Access Compliance Report

Public Rights-of-Way

Intersection ID: 15303	Main Street: IDEAL_WY	Cross Street: MCDONALD_AV	Location: SW
ADA ID: 339EB504694A	Ramp Type: PerpDiag	Initial Pass/Fail: Fail	Overall Compliance: No
		Severity Score: 25

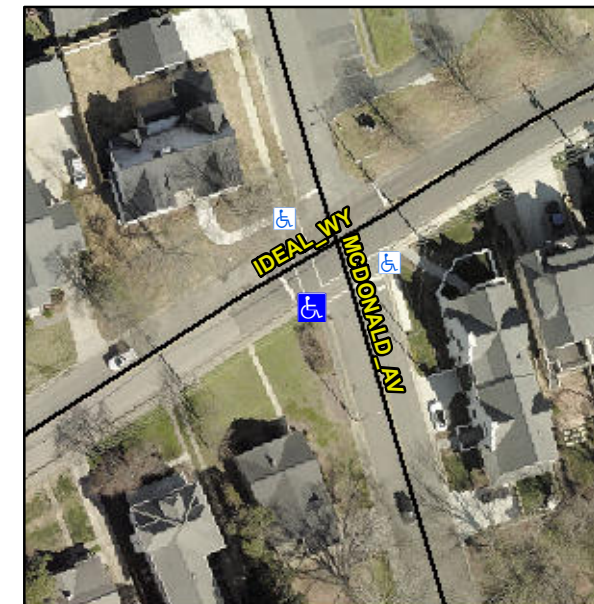
Not Found, R304.5.3

Compliance	Description	Data	Compliance	Description	Data
N/A	Ramp Length (in)	44.0	Yes	Ramp Slope (%)	7.6
Yes	Ramp Width (in)	48.0	No	Ramp XSlope (%)	15.2
N/A	Flare Type LT	N/A	N/A	Flare Type RT	N/A
N/A	Flare Slope LT (%)	N/A	N/A	Flare Slope RT (%)	N/A
N/A	Flare Traversable LT?	N/A	N/A	Flare Traversable RT?	N/A
N/A	Landing Length (in)	N/A	N/A	DWS Provided?	N/A
N/A	Landing Width (in)	N/A	N/A	DWS Contrast?	N/A
N/A	Landing Slope (%)	N/A	N/A	DWS Length (in)	N/A
N/A	Landing X Slope (%)	N/A	N/A	DWS Full Width?	N/A
N/A	Landing Curb? (Y/N)	N/A	N/A	DWS Offset (in)	N/A
N/A	Shared Landing?	N/A			
N/A	Gutter Ponding?	N/A	N/A	Gutter Slope (%)	N/A
N/A	Gutter Lip Ht (in)	1.0	N/A	Gutter X Slope (%)	N/A
N/A	Painted X Walk1?	No	N/A	Painted X Walk2?	No
	X Walk 1 Direction	To NE		X Walk 2 Direction	To N
N/A	X Walk 1 Width (in)	N/A	N/A	X Walk 2 Width (in)	N/A
	X Walk 1 Slope (%)	0.8		X Walk 2 Slope (%)	9.0
	X Walk 1 X Slope (%)	10.1		X Walk 2 X Slope (%)	1.3

Remove & Replace Curb Ramp With Two New Directional Ramps or Equivalent.
